**STAFF REPORT 08-12-2020 REGULAR MEETING**

**APPLICATION NUMBER: 20-6620**

**ADDRESS: 1681-1683 ATKINSON STREET**

**SCOPE: REPLACE EXISTING WOOD & VINYL WINDOWS**

# existing wood windows - 1681/1683 Atkinson

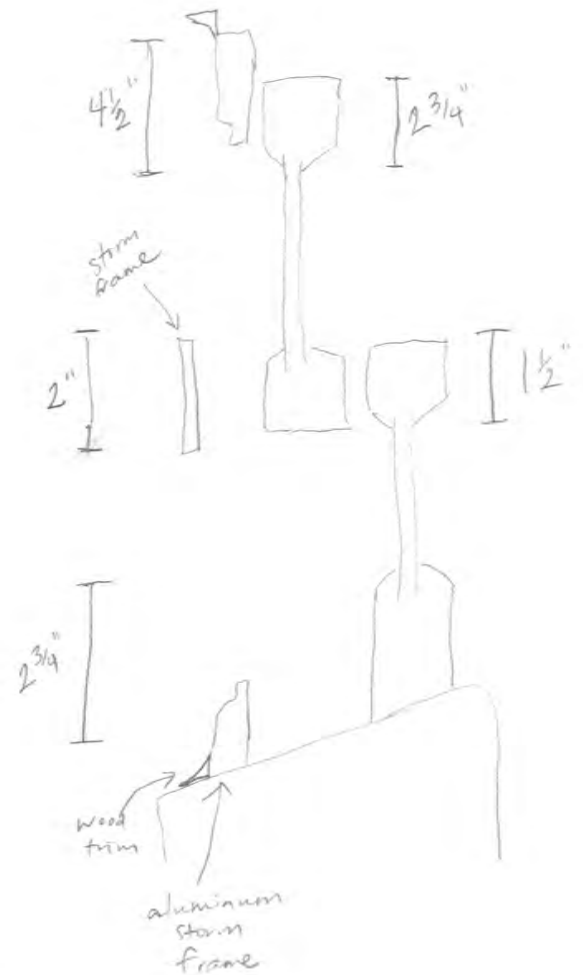
- In comparing the three (3) replacement options – Fibrex (Andersen 100 Series), Wood (Jeldwen Custom Wood Windows/Sitrine Windows), and Aluminum-clad wood (Andersen E Series) – it is staff’s observation that the wood replacement windows (Jeldwen Custom Wood/Sitrine Windows) are the closest in profile and sight line dimensions to the existing wood windows. Pulling just one dimension from the drawings for a quick comparison - the vertical dimension of the meeting rail:

- Existing Wood Windows: 1 1/2”
  - Fibrex (Andersen 100 Series) Replacement: 2 3/16” (11/16” larger than existing)
  - Aluminum-clad wood (Andersen E Series) Replacement: 1 43/64” (11/64” larger than existing)

Fibrex (Andersen 100 Series) replacement product, which is the proposed replacement product in this application, differs the most in profile and sight line dimensions and design. The Fibrex (Andersen 100 Series) replacement product, in general, has larger dimensions than the existing wood windows and, therefore, will appear “thicker” than the existing wood windows.

- The replacement windows are to be wood replacement windows, using the Jeldwen Custom Wood Windows/Sightline Windows as the basis of design for profile and sightline dimensions and design rather than the proposed Fibrex (Andersen 100 Series) replacement product.
- The light configuration is to be 1/1 without muntins in either sash.
- The applicant shall revise the submission to reflect the updated replacement window product and light configuration and submit to HDC staff for review and approval prior to pulling the building permit for the project.
